**FILE** P. I. No. 0003787, Troup County **OFFICE** Preconstruction  
STP-0003-00(787)  
I-85 Exit Ramps at SR 18 **DATE** May 12, 2005

**SUBJECT** REVISED PROJECT CONCEPT REPORT APPROVAL

SUBJECT: Revised Project Concept Report

## **REVISED PROJECT CONCEPT REPORT**

I-85 EXIT RAMP TYPICAL SECTION

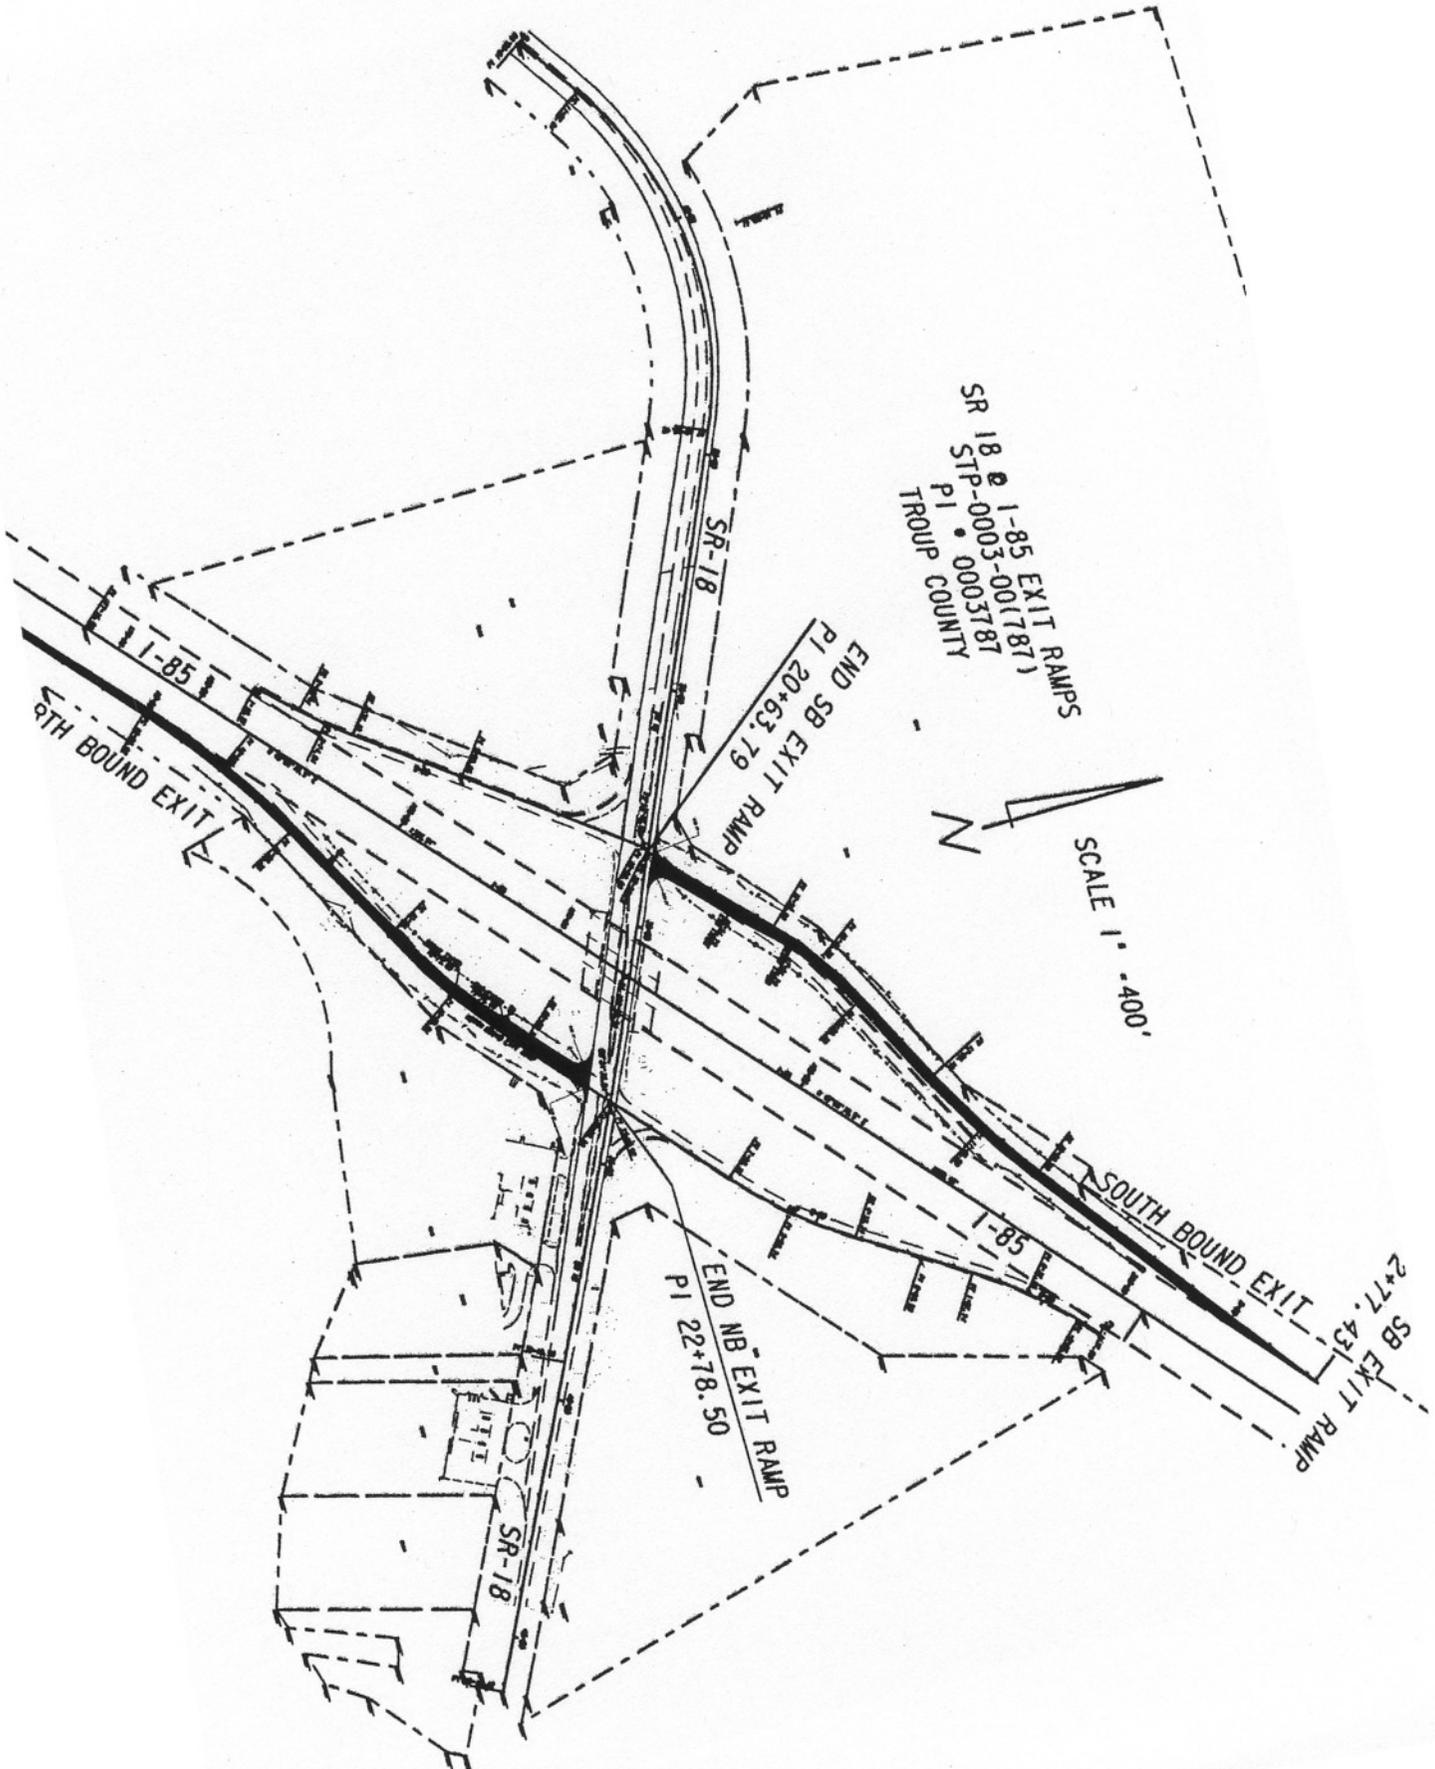
**Typical Sections**

The revised typical section changes the inside shoulder width to 8-feet with 4-feet paved and the outside shoulder width to 12-feet with 10-feet paved. The paved outside shoulder will facilitate disabled vehicles to completely pull out of the ramp through lane. In the design year, the ramps will experience 13% truck traffic. The 24-hour truck traffic is 15%. *See the attached typical section.*

I-85 Exit Ramps @ S.R. 18 (Existing)

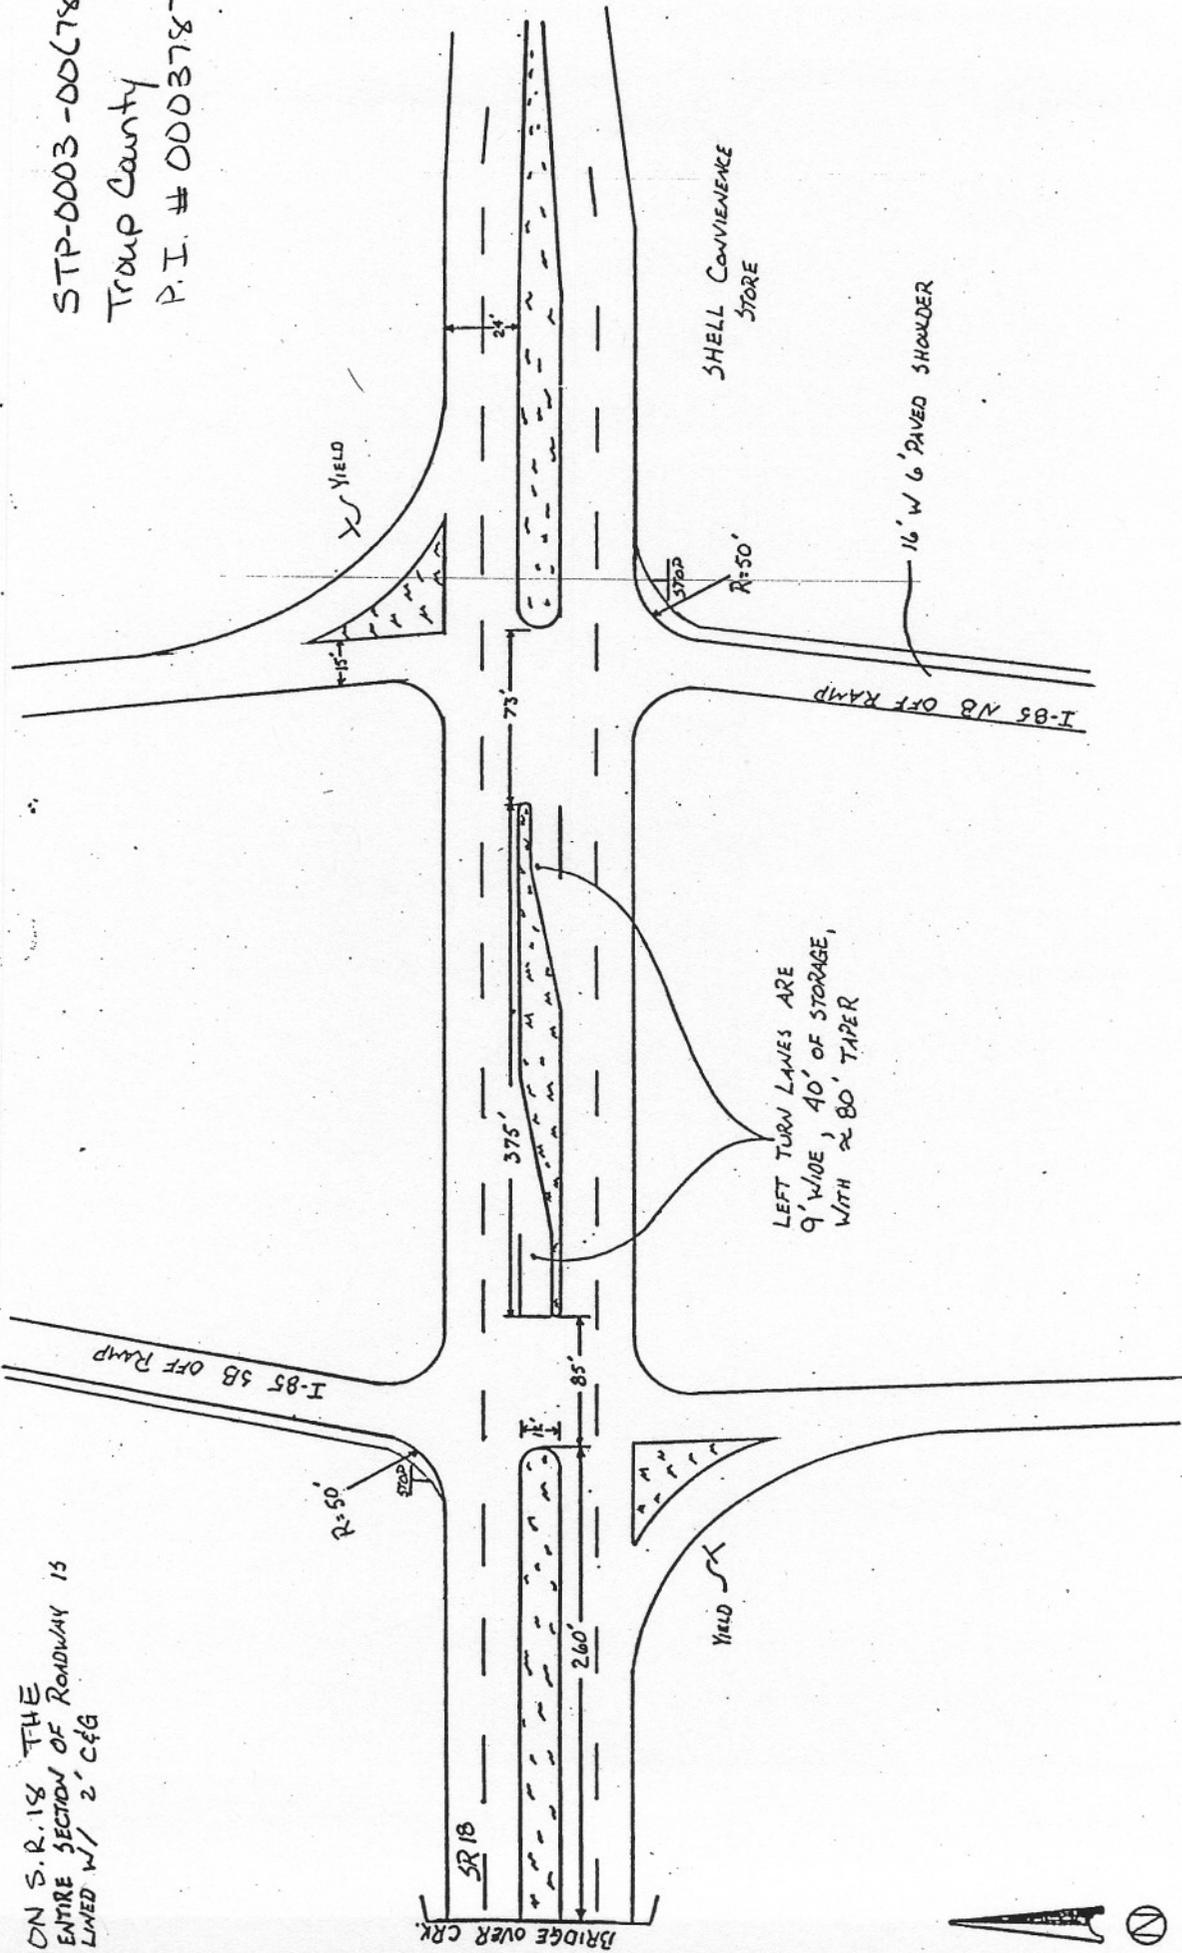
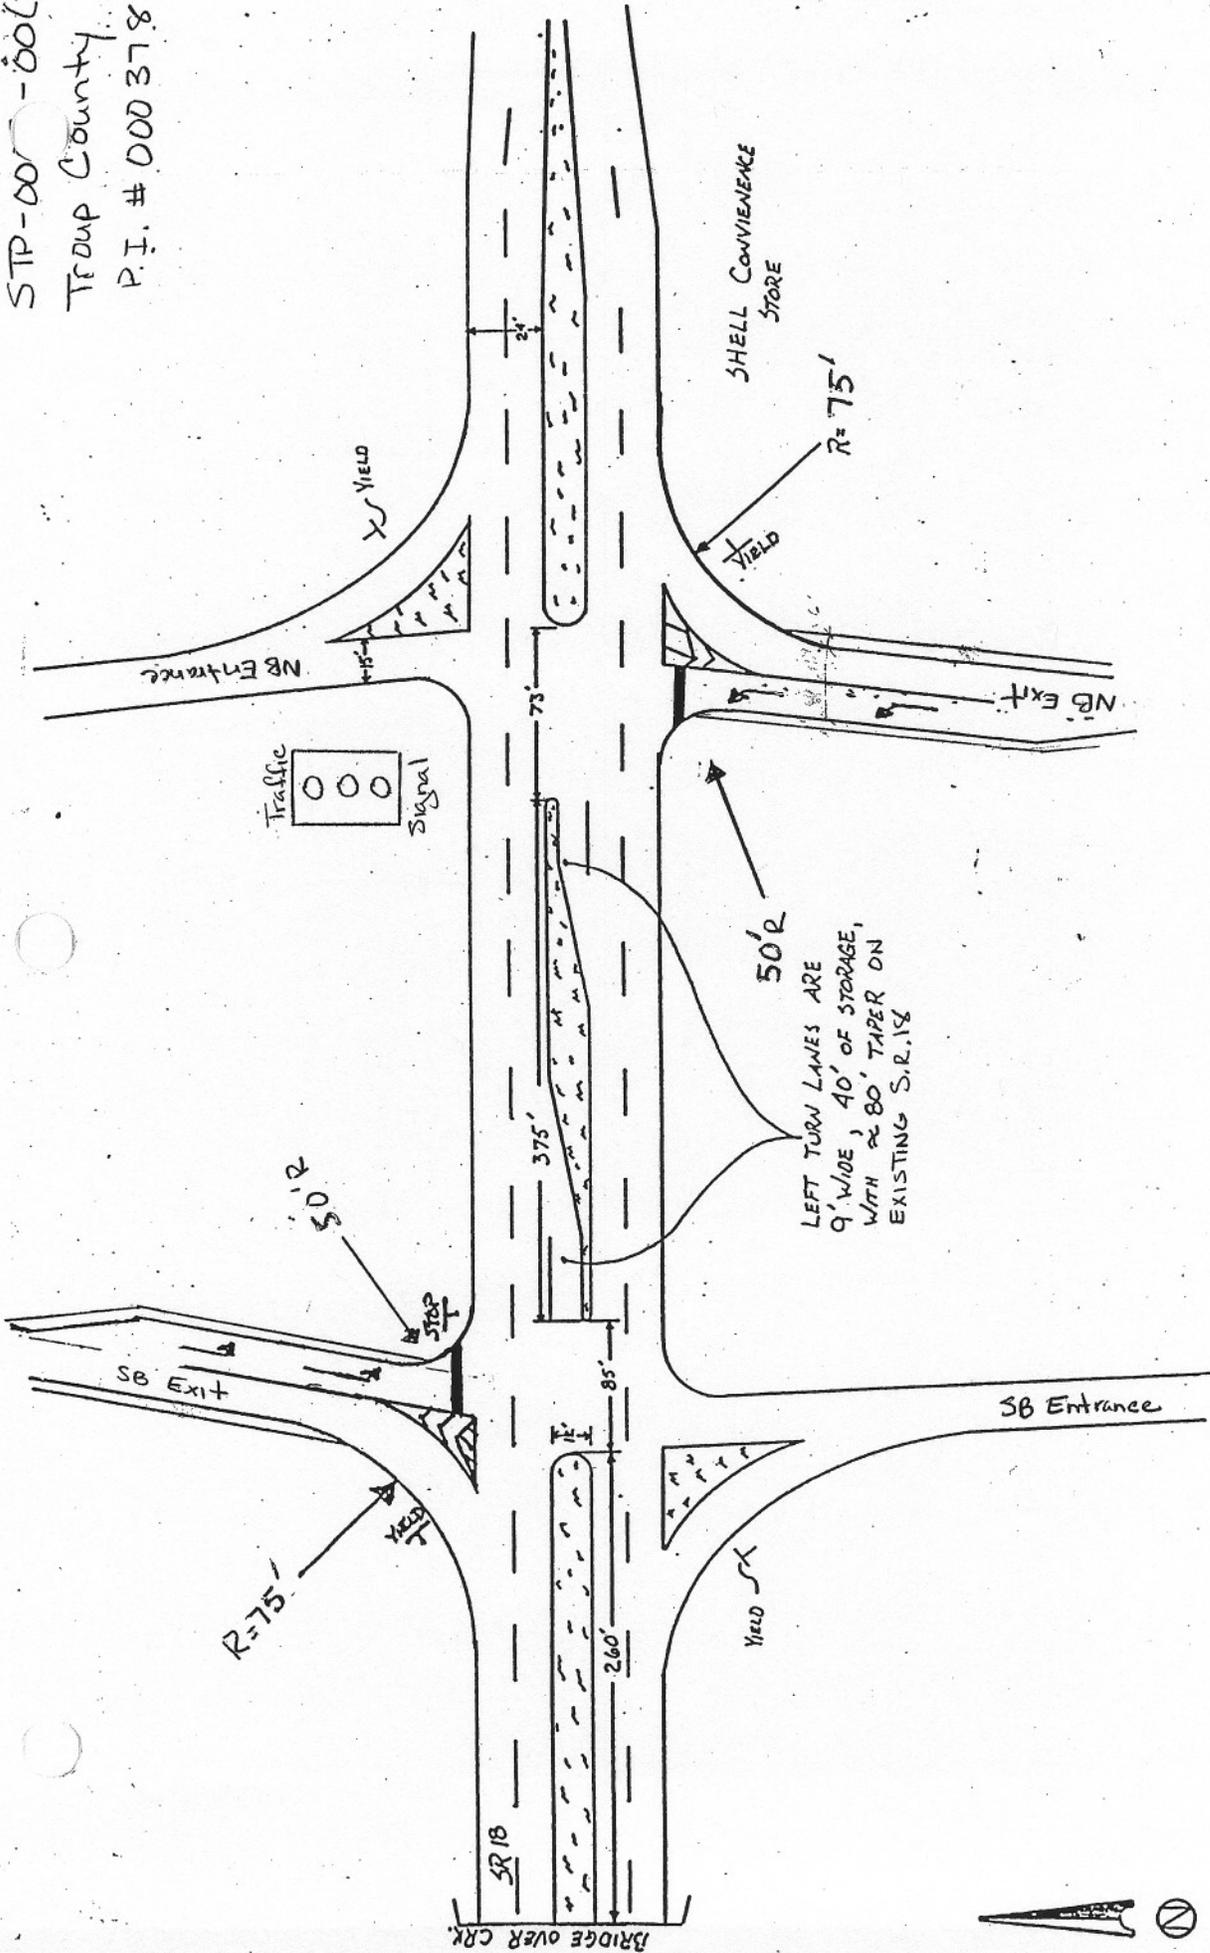
### Traffic Control

In the existing condition and the currently approved concept, both ramp intersections with SR 18 are stop controlled. This concept revision recommends to signalize the northbound ramp intersection with SR 18 and to retain stop control at the southbound ramp intersection with SR 18.

HCS analysis of the currently approved concept indicates that maintaining stop control at both intersections does not improve the operation of the northbound exit ramp at SR 18. Even with an added left turn lane from the ramp to SR 18, the northbound exit ramp operates at a.m. LOS F and p.m. LOS E in the design year, with stop control. The southbound exit ramp operates at LOS C in the design year with an added left turn lane under stop control.

Installing a traffic signal at the northbound ramp intersection with SR 18 makes the northbound exit ramp operate at a.m. LOS D and p.m. LOS C in the design year. The southbound exit ramp operates at a.m. LOS C and improves to p.m. LOS B. *See the attached Intersection Capacity Analysis Summary.*
